Response to review of referee #1

William Santini, Benoît Camenen, Jérôme Le Coz, Philippe Vauchel and Jean-Michel Martinez

15/03/2019

Response to review of referee #2

New figure 3: Observed ratios $\alpha = \langle C \rangle / C(h)$ of total mean concentration to the total index concentration sampled at the water surface vs sand mass fraction X_s .

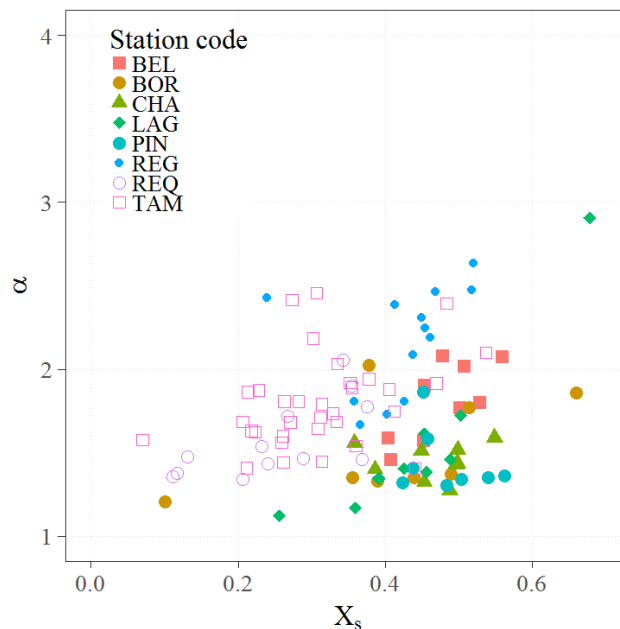
- p. 12 - l. 7: This is not what I see in Fig. 3... Aren't the axes swapped? And is the color-coding right? The figure and the text sound contradictory, but I might be wrong.

According to referee #1 and #2 reports, Fig.3 is indeed quite difficult to read. We modified the figure in order to better detect the increase of $\alpha = \langle C \rangle / C(h)$ with sand mass fraction X_s . The concentration measurement uncertainty and the shear stress variability during the hydrological cycle explain the observed dispersion.

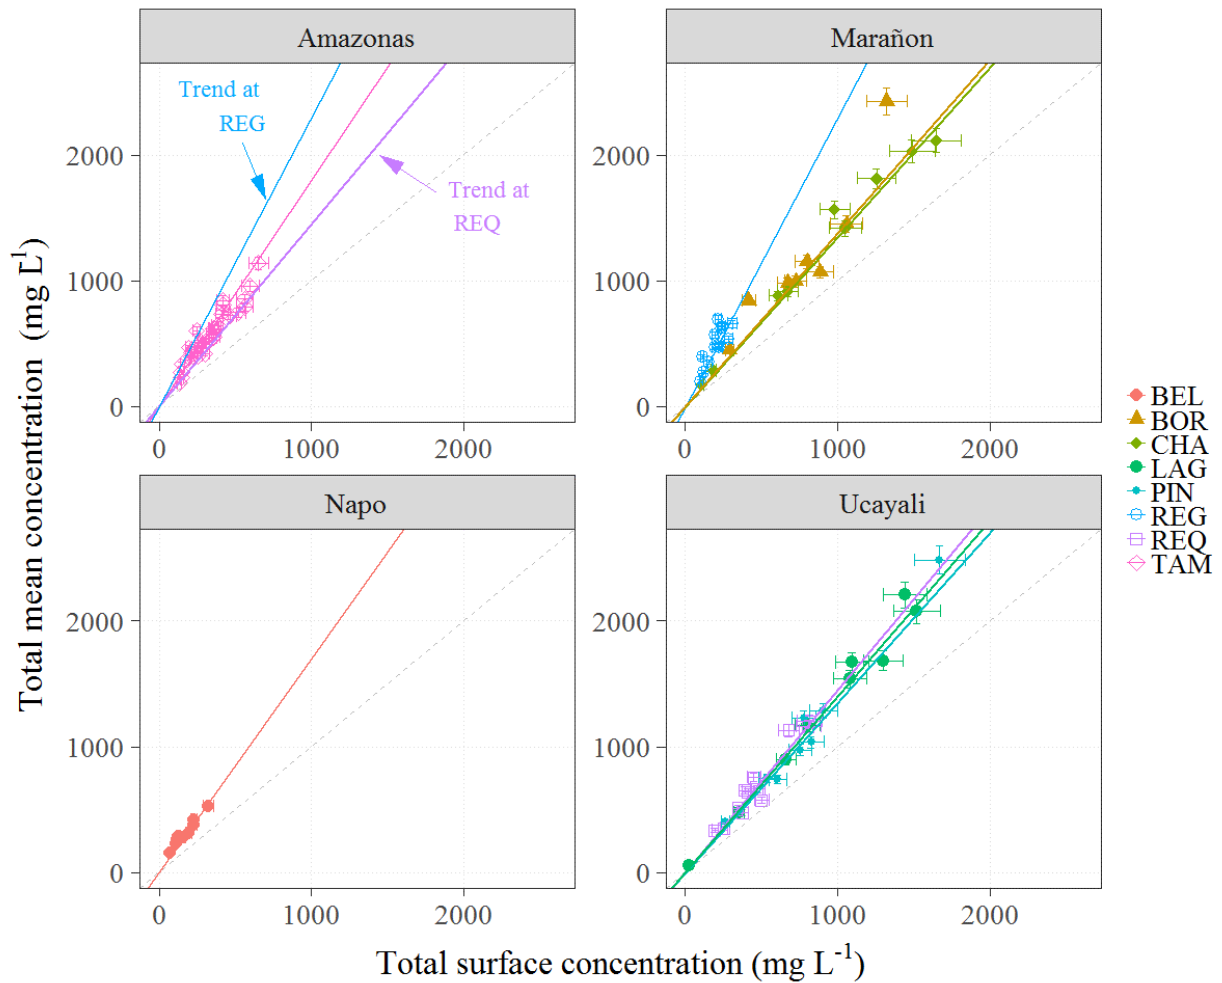
- p. 19 - l. 9: Where does this relationship between “ $\langle u \rangle$ ” and “ h ” come from?

Assuming the stream's velocity profile can be modeled by the logarithmic profile ($u(z) = \frac{u_*}{\kappa} \ln \left(\frac{z}{z_0} \right)$), it can be shown that the depth-integrated velocity $\langle u \rangle$ is approximatively equal to: $\langle u \rangle \cong \frac{h}{e} \cong 0.37h$:

The sentence was rephrased in the revised ms (p.20, l.9).

Figure 10: (a) Prediction of the mean diameter d_s at the TAM gauging station for $u_* = 0.12 \text{ m s}^{-1}$ (mean flow conditions) (b) Predicted vs measured d_s at BEL, REQ, REG and TAM. Dashed line: first bisector. Continue line: best fit.

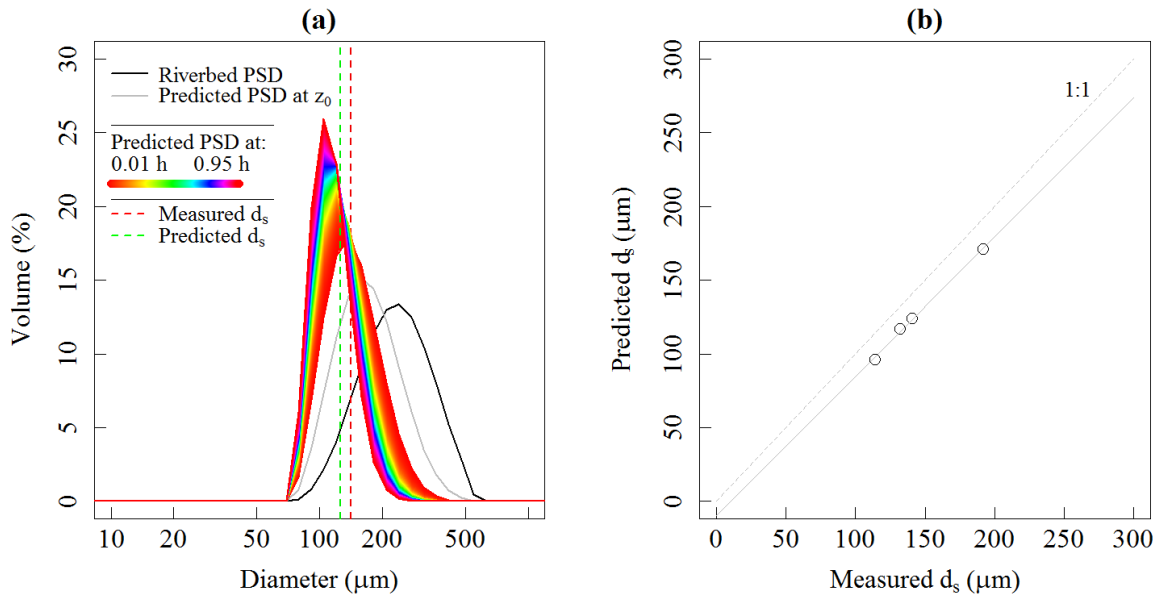
- Figure 10: What about the other stations than those shown in panel (b), why aren't they represented? And it would make more sense to me to plot simply “predicted” vs. “measured” (i.e. without the 1.1-factor) and then to plot the 1:1, and/or 1.1:1 line – at least because in this case the caption is wrong, strictly speaking.

Samples for the characterization of the bed material PSD were collected only at four sites: BEL (2 PSD), REQ (1 PSD), REG (1 PSD) and TAM (2 PSD). Please note that for TAM and BEL, only the average diameter of the two PSD measured is plotted. There are no PSD measurements for the bed material at BOR, LAG, PIN and CHA.

Please find below the new figure 10 with the modification asked; this figure has been added to the revised ms.

Figure RC2_1: Ratio β_ϕ of sediment diffusivity to momentum diffusivity vs total concentration.

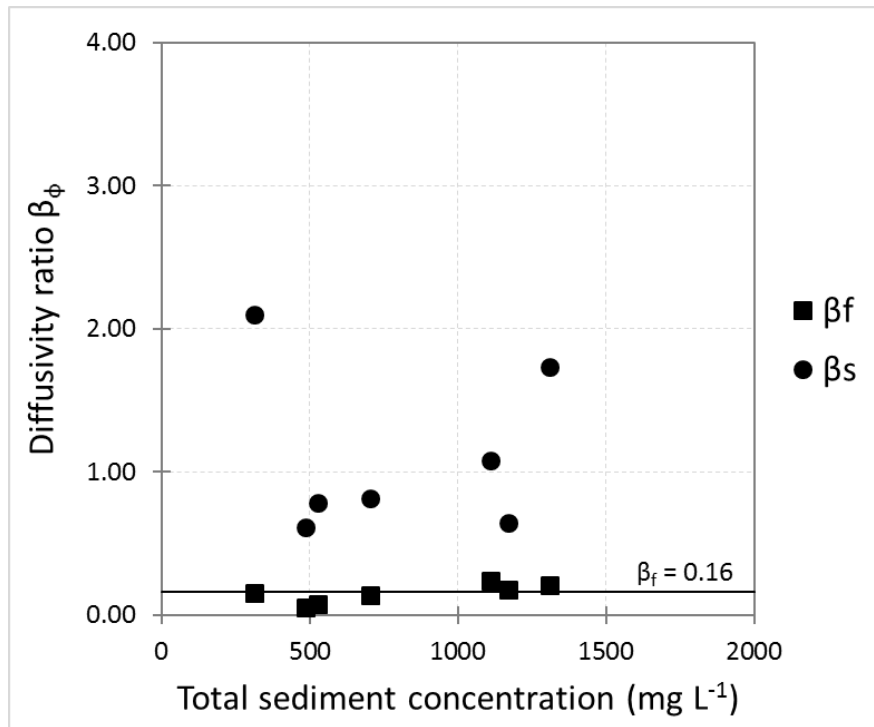
I would like the authors to clarify a couple of assumptions that underpin their work. On p.8 the authors state the assumption used in this work is that sediment diffusivity is concentration-independent. I think it would be worth providing more detail as to the validity of this assumption as it underpins the entirety of the following work. Are there locations (particularly in large river systems where sediment concentrations are very high - including the Amazon) where diffusivity may become dependent on sediment concentration? What are the implications of this assumption failing on the rest of the work presented by the authors?

Thank you for raising this very interesting issue about the effect of particle concentration on sediment diffusivity, which is a long-standing problem for the scientific community interested in the sediment transport (e.g. Van Rijn, 1984; Graf and Cellino, 2002; Pal and Ghoshal, 2016; Gualtieri et al. 2017).

P.8, l.25, we effectively assume that the sediment diffusivity ε_ϕ is concentration-independent as many authors did (Van Rijn, 194, Camenen & Larson, 2008, among others). The coefficient φ introduced by Van Rijn (1984) to account for the dampening of the fluid turbulence by the sediment particles is indeed neglected in most models. Its influence on the sediment diffusivity would be visible for high concentrations only ($C > 10\text{g/L}$) that never occurred in the lowland Amazonian rivers. Also, any empirical equation for β_ϕ as the one proposed here could intrinsically include effects of damping as it is fitted to experimental data.

Moreover, the data do not show relationship between the concentration and β_ϕ (Fig. 8b or Fig. RC2_1).

Anyway, the concentration influence on the sediment diffusivity could be a secondary factor for the large Amazonian Rivers, such as the particle characteristics (shape, grain size, density...), the aggregation phenomenon, or the level of stratification of the flow (Pal and Ghoshal, 2016; Gualtieri et al. 2017). Unfortunately, the uncertainties of our dataset collected in field conditions do not allow us to further investigate the influence of these secondary order factors on the sediment diffusivity.

Figure RC2_2: (a) comparison between a typical velocity gradient (red line) and concentration gradient for various Rouse numbers. (b) ratio of concentration to velocity gradient with depth.

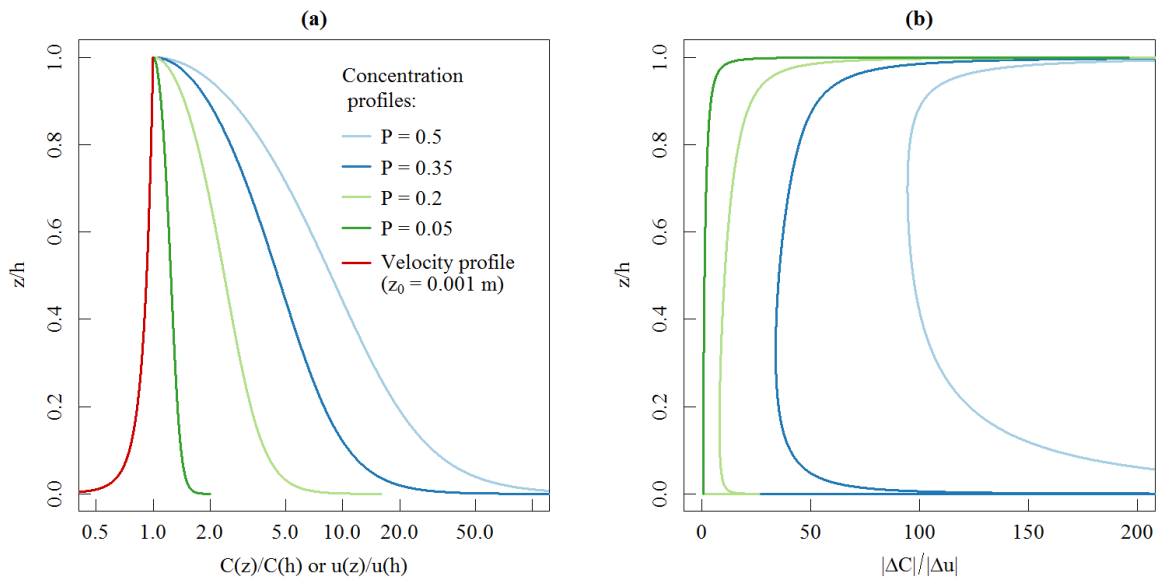
Additionally, on p9. the authors make the assumption that the "velocity distribution is vertically uniform" (line 17). This may be the case in straight reaches of large rivers at low and mean flows, but does this assumption hold at the highest of flows where turbulence is likely to be increased, and also when highest sediment yields are likely to be evident? Does it also hold for meanders or regions with large bedforms inducing turbulence into the vertical flow profiles? Again, what are the implications of this assumption for the methodology applied and in the results that the authors achieve?

By "the velocity distribution is vertically uniform", we first mean that the velocity gradients are negligible in comparison to the sand concentration gradients on the water column (Fig. RC2_2). Indeed, for the range of nominal Rouse numbers considered in this work ($P_\phi < 0.6$), the bottom concentration gradient has little influence on $\langle C_\phi \rangle$ because the velocity strongly decrease in this region of the flow ($\sim [z_0 - 0.1 h]$). Moreover, for these regimes of suspension, the main part of the sediment load is transported above this particular region of the flow. Hence, the influence of the velocity distribution on the depth-averaged concentration can be neglected in Eq.(1).

Conversely, for sediment profiles with higher Rouse numbers ($P_\phi \geq 0.6$), the main bulk of sediment is transported near the riverbed, where the velocity distribution experiences its strongest gradient. Then, it is necessary to weight the depth-integrated concentration by the velocity distribution. The higher the Rouse number, the more it will be necessary to describe accurately the profiles of concentration and velocity near the riverbed (Fig. RC2_3) to calculate $\langle C_\phi \rangle$.

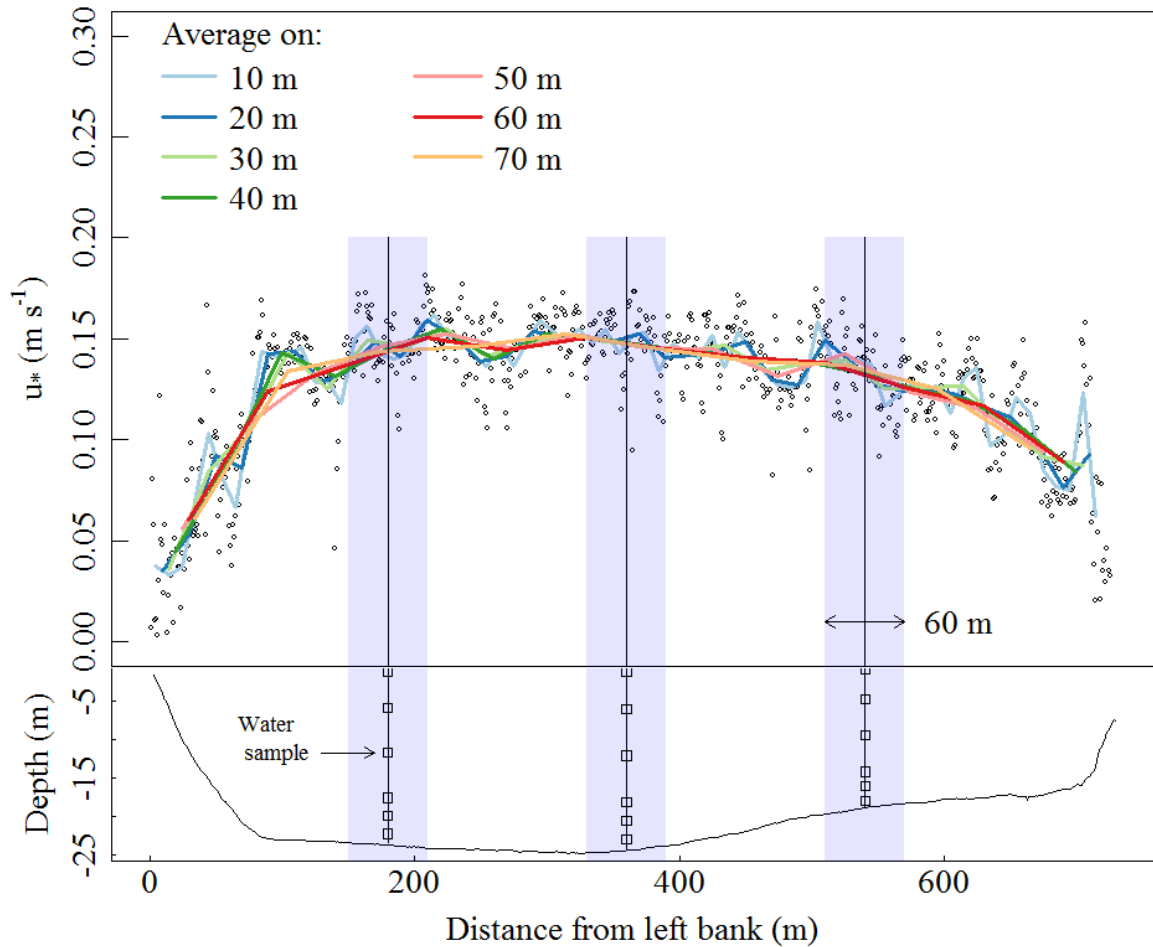
P.11, line 9: could the authors explain why the velocity profiles are averaged over 60m? How sensitive are the results to this averaging? How does this averaging affect the sediment distributions near river banks that may be <60 m from the bank?

The ADCP velocity profiles were averaged over a spanwise length of ~ 60 m around each concentration profile position in order to dampen the influence of velocity fluctuations, local perturbations, and ADCP measurement errors. Indeed, in this work, we chose to consider flow conditions at a reach scale rather than point-to-point flow conditions.

To obtain representative velocity profiles, and to derive robust u_* values from these profiles, we found that about 30 ADCP “ensembles” (i.e. measurement verticals of velocity) were required, corresponding to a spatial average of about 40 to 70 m in the cross-sectional direction. This was consistent with the methodology applied by Armijos et al. (2016) (50-60 ensembles, corresponding to 10% of the total width of the section) or Lupker et al., 2011 (30 ensembles, 40 to 70 m). Following these findings, the velocity profiles were averaged over a spanwise length of about 60 m around each concentration profile position.

We rephrased the section 2.5 in the revised manuscript (p.11, l.18 – 26) to explain why the profiles were averaged over 60 m in the transverse direction.

New figure 1: Observed ratios $\alpha = \langle C \rangle / C(h)$ of total mean concentration to the total surface concentration, stacked by river basin, with trend lines. For the Amazonas River basin at TAM, the REG and REQ trend lines were reported. Dashed lines: first bisector.

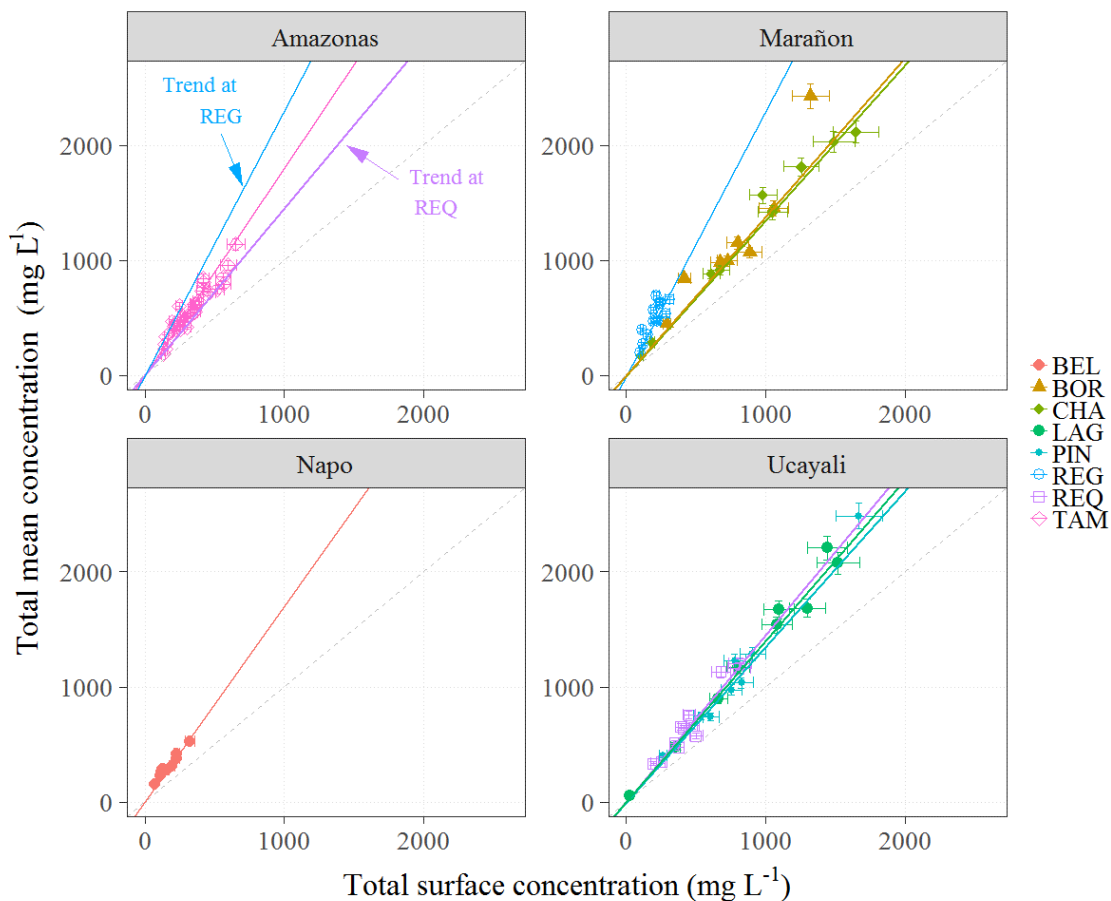
Figure 1: Could the authors add error bars to show the range of standard of concentrations measured?

Here the figure with error bars which have been added to the ms.

New figure 3: Observed ratios $\alpha = \langle C \rangle / C(h)$ vs sand mass fraction X_s .

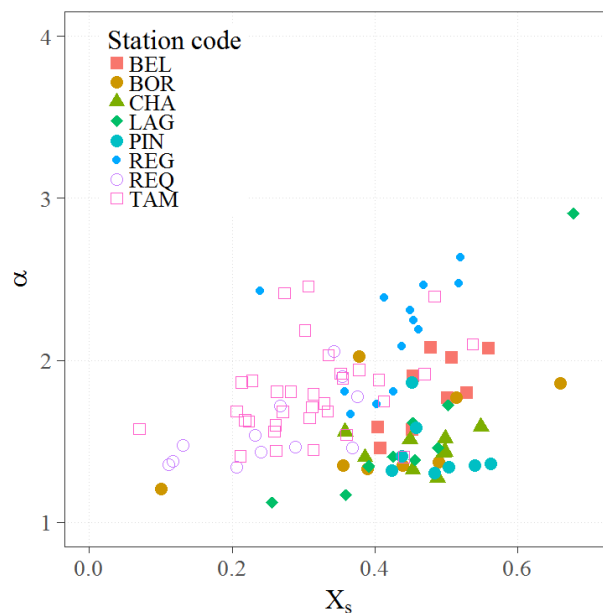
Figure 3: I have trouble differentiating the red and blue scale bar here. I would recommend changing to something less of an issue or those of us who are colour blind. I also note that on p12 line 8, figure 3 is described as showing the "sand mass fraction...on the ratio alpha" whereas figure 3 depicts concentration rather than ratio alpha.

According to referee #1 and #2 reports, Fig.3 is quite difficult to read. We propose the following figure instead, where we can see the increase of $\alpha = \langle C \rangle / C(h)$ with the sand mass fraction X_s . The concentration uncertainty and the shear stress variability during the hydrological cycle explain the dispersion observed in this figure.

Figure 2: Measured-Observed ratios $\alpha = (C)/C(h)$ of total mean concentration to the total surface concentration, stacked by river basin, with trend lines. For the Amazonas River basin at TAM (upper-left panel), the REG and REQ trend lines were reported. Dashed lines: first bisector.

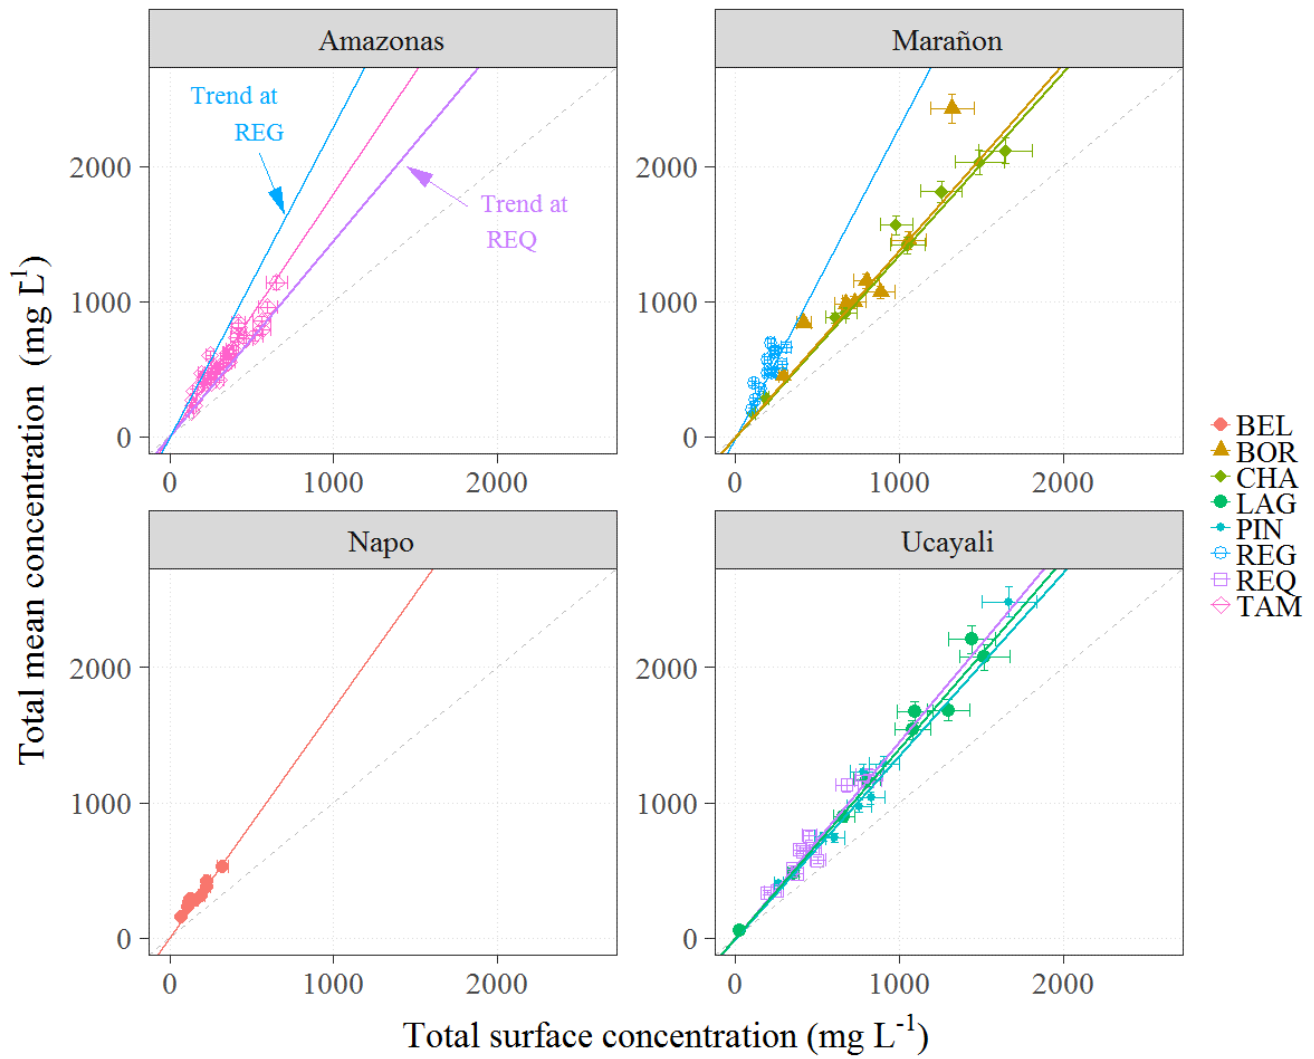
- Figure 2: It took me a while to understand what the blue and purple lines are in the upper-left panel - it would be better to clearly indicate what they are within the panel.

Please find below a new figure 2 with a short text in the upper left panel. This figure has been added to the revised ms.

New figure 2: Observed ratios $\alpha = \langle C \rangle / C(h)$ of total mean concentration to the total surface concentration, stacked by river basin, with trend lines. For the Amazonas River basin at TAM (upper-left panel), the REG and REQ trend lines were reported. Dashed lines: first bisector.

Figure 5: Dimensionless sediment diffusivity values-coefficient derived from the measured concentration profiles.

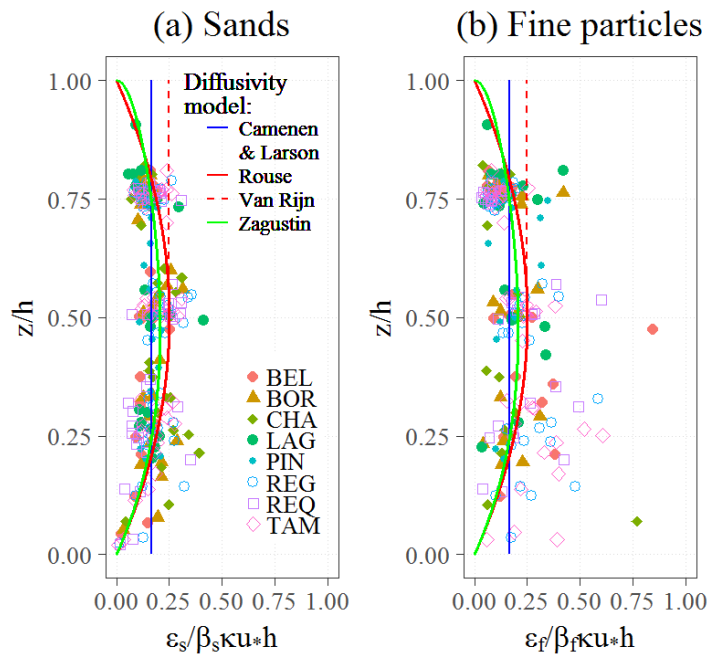
- What the x-axis represents is a bit mysterious, as I did not see any explanation in the text. I guess this is because this is a non-dimensional number that is expected to be the same at all locations and in all hydrological conditions?

We guess it is the x-axis of Fig. 5 and not Fig. 2? If it is Fig. 5, yes, it is a non-dimensional number, and yes, the diffusivity profile is expected to follow the theoretical models (Camenen & Larson, Rouse, Van Rijn or Zagustin) at all locations and in all hydrological conditions.

The caption for the figure 5 was modified: “Dimensionless sediment diffusivity coefficient derived from the measured concentration profiles”
